Attic #8

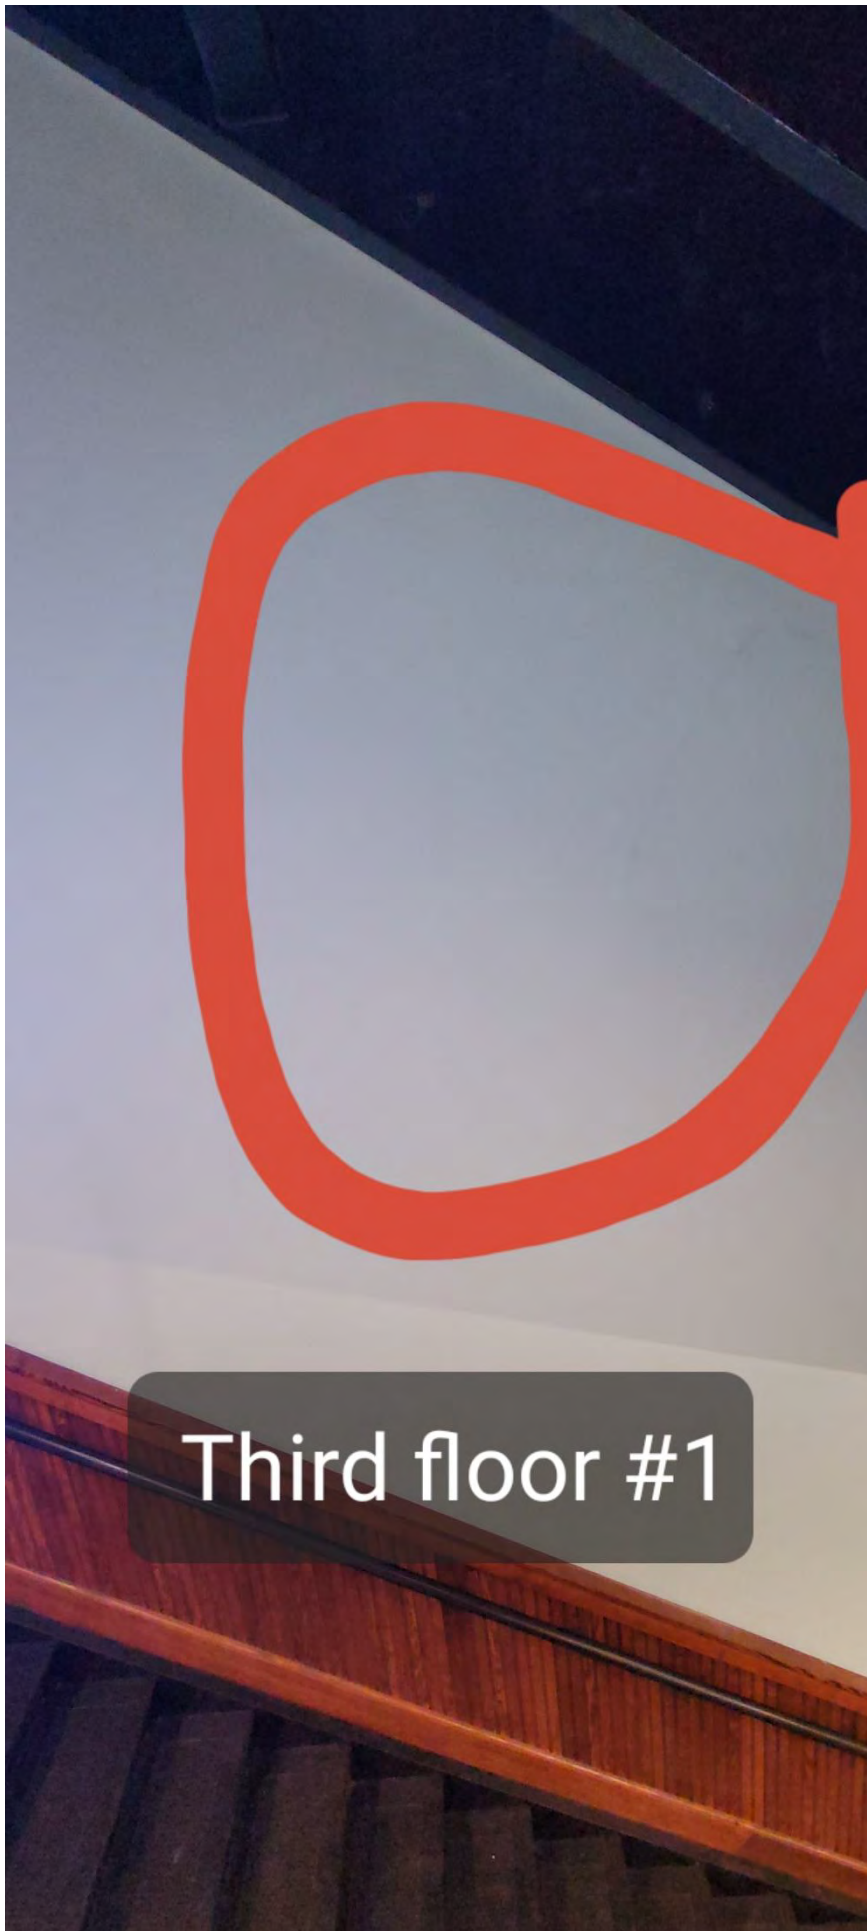
*	8	Cupola sections not sealed / insulated	
	9	AHUs do not have secondary drain line	
	10		
	11		
	12		
	13		
3rd floor			
*	1	Crack in wall under attic stairwell

Third floor #2

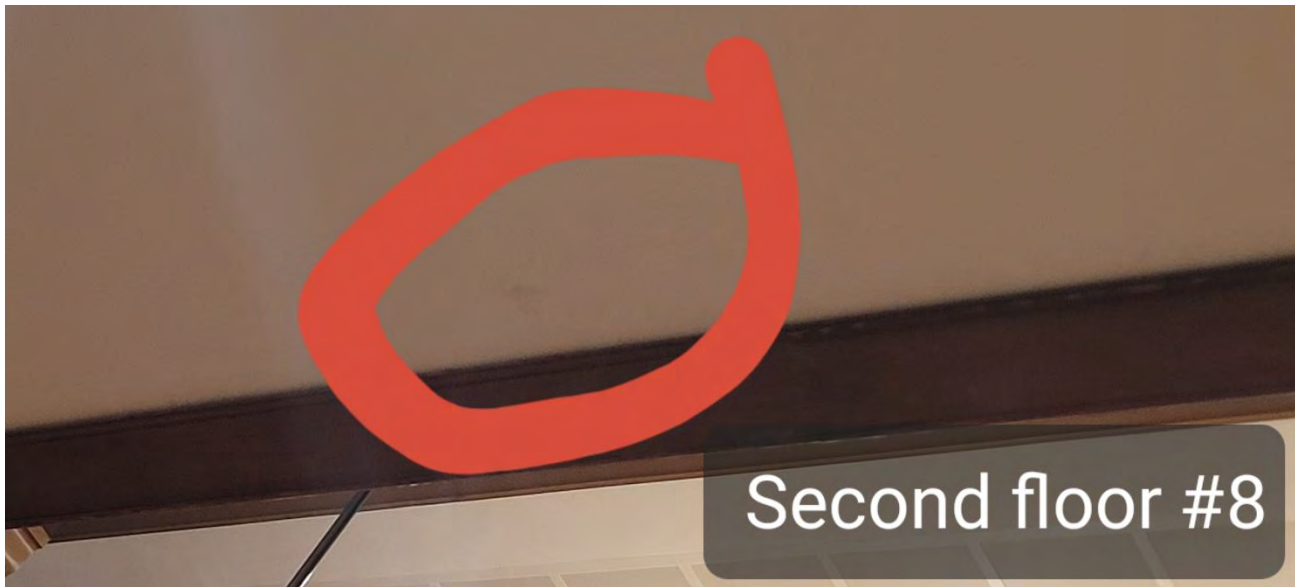
*	2	Wall damage NE & NW corner of the courtroom	
	3	Court room doors not working properly	
	4	IT closet fire sprinkler cap not flush with ceiling	
	5	Hand rail to attic has pinch point on hand halfway up	
	6	No battery backup lighting	
	7	Office 304 window hardware broken

First floor #22

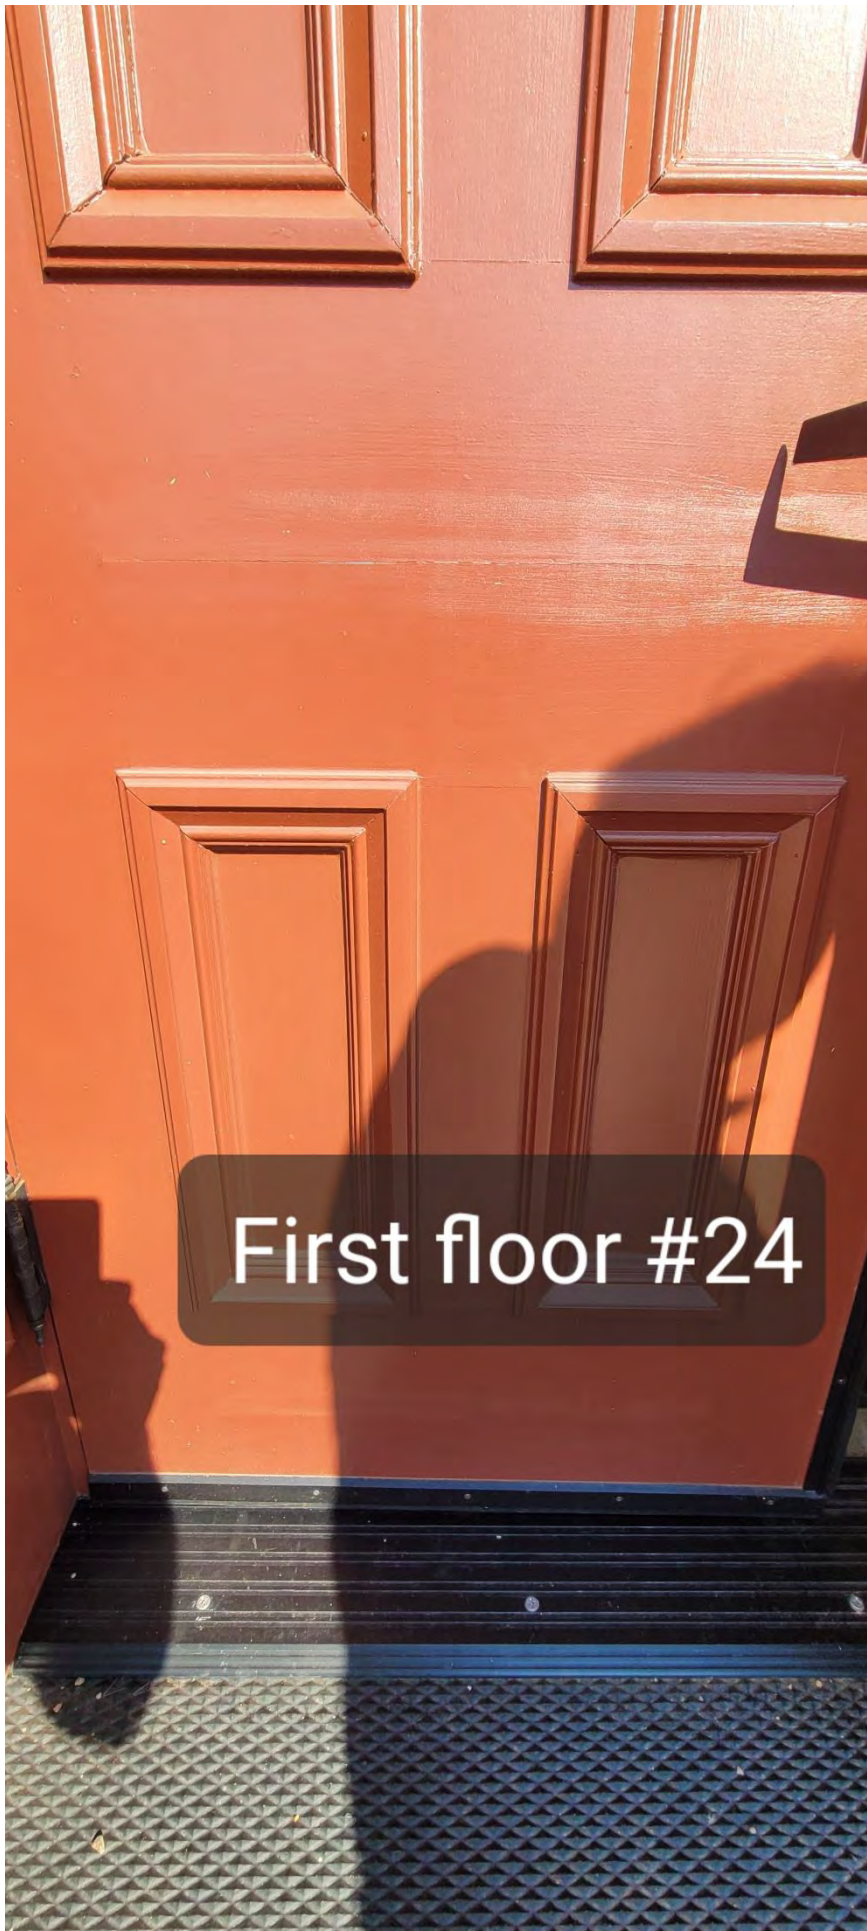
*	22	Rm 110 ceiling bowed	
*	23	East entrance ceiling gap by east wall	
*	24	All entrance doors trim is coming apart and at doors jointing	
*	25	Paint on floor at West stairwell from painting black stairwell

Outside #5

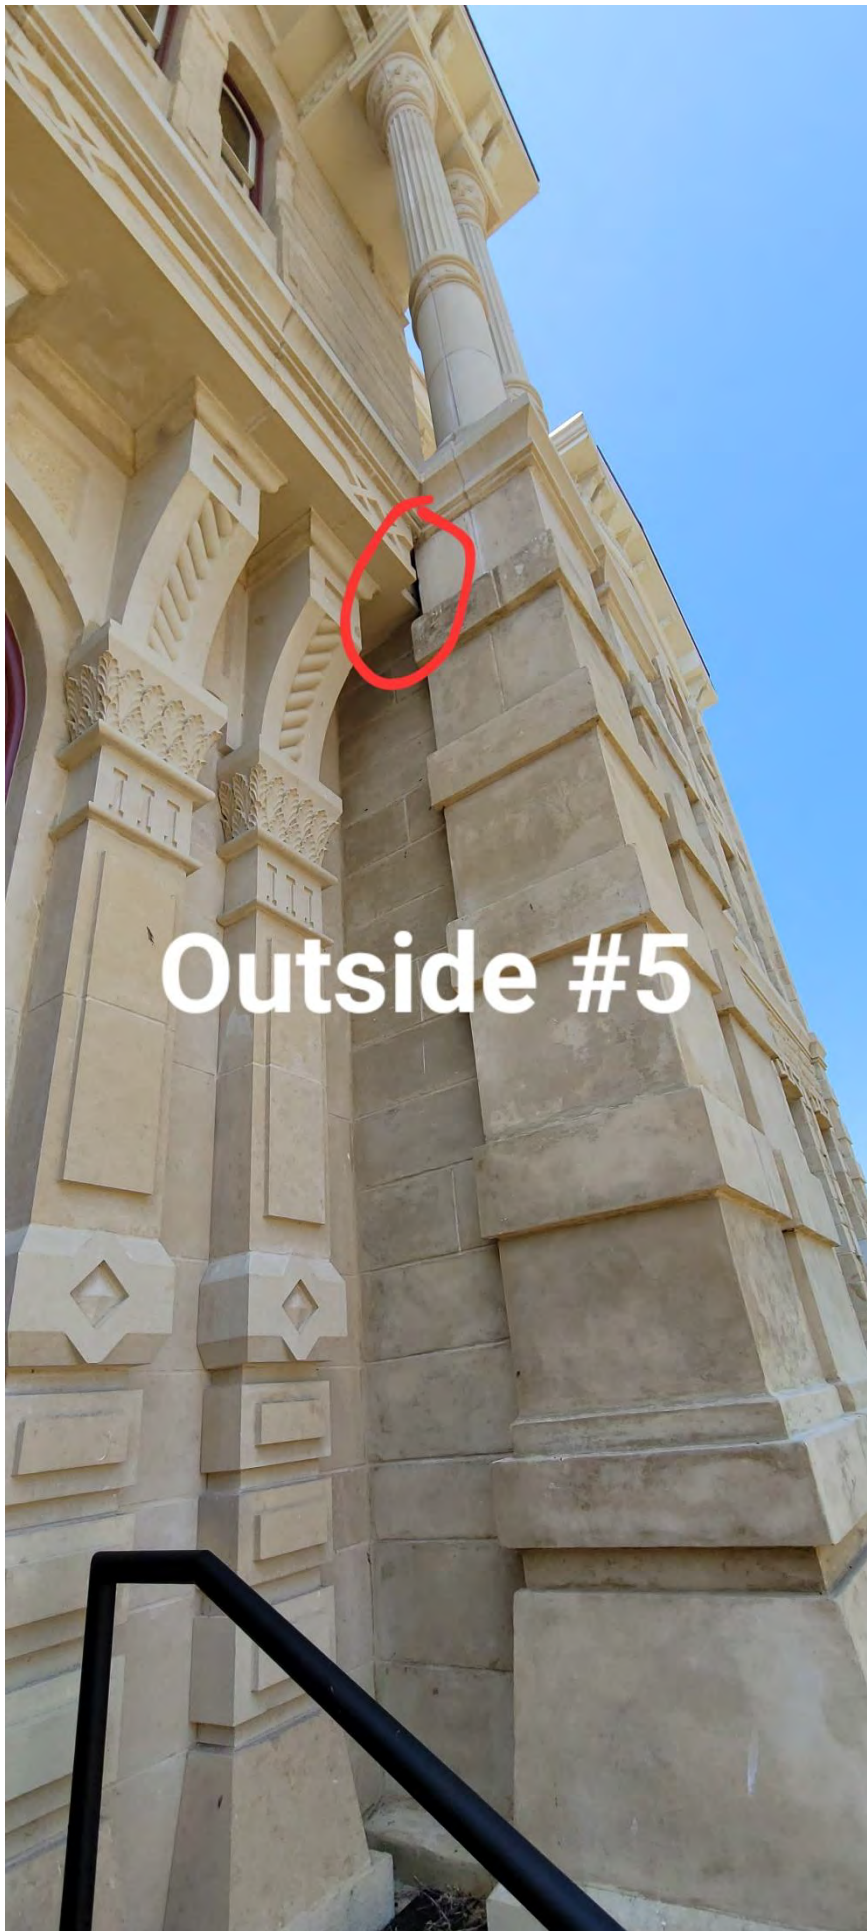
*	5	All entrances at above are open voids and birds are nesting	
	6	Handicapp South rail needs painting	
*	7	Lumps in grass from lifts	
*	8	Stone pieces falling off all around building
